61 Fountainhall Road EH9 2LH

Planning Application 21/00920/FUL

OBJECTION from Grange Association

1 April 2021

Figure 4: Proposed site layout

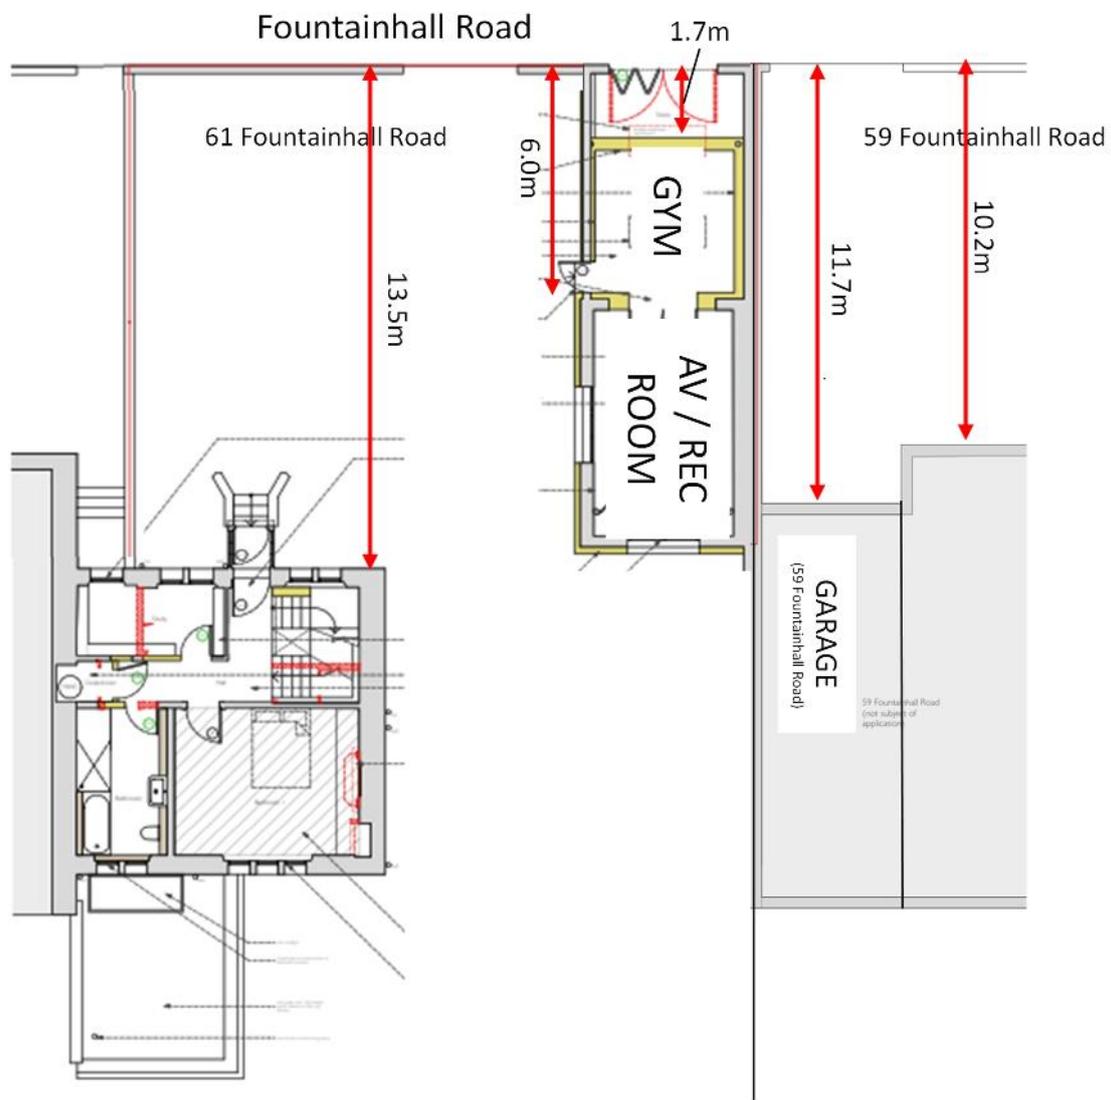
The proposed new habitable rooms would be forward of the building line and would come within 1.7m of the street boundary.

We do not consider habitable accommodation forward of the building line to be acceptable in any circumstances in the conservation area.

We request that this application for habitable accommodation forward of the building line is refused and the applicant is encouraged, in descending order of preference, to:

- Demolish the car port and garage and return the land to soft landscaping; or
- Demolish the car port and renovate the hard-standing and entrance gates such that at least one vehicle can be stored regularly off-street.

Figure 6: South elevation – flue omitted

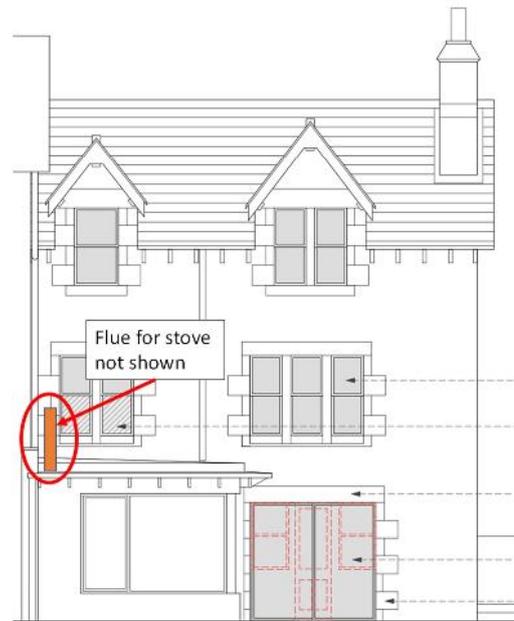
The plan drawings submitted with the application show a “new stove in garden room” and “new flue for wood burning stove”. This flue will be within 700mm of the site boundary. The elevation drawings omit this flue and so its proposed height is unknown. The applicant should be required to resubmit the elevation drawings to show the flue, its materials, colour and height so that any non-compliance can be assessed.

Notwithstanding the omission from the drawings, we consider a new flue from a wood-burning stove should not be installed so close to a neighbour’s boundary and only a few metres from the neighbour’s rear windows, where smoke and fumes could enter the house when the windows are open. The smell and pollution that would arise from this flue would be unacceptable. We request that permission for this flue be refused.
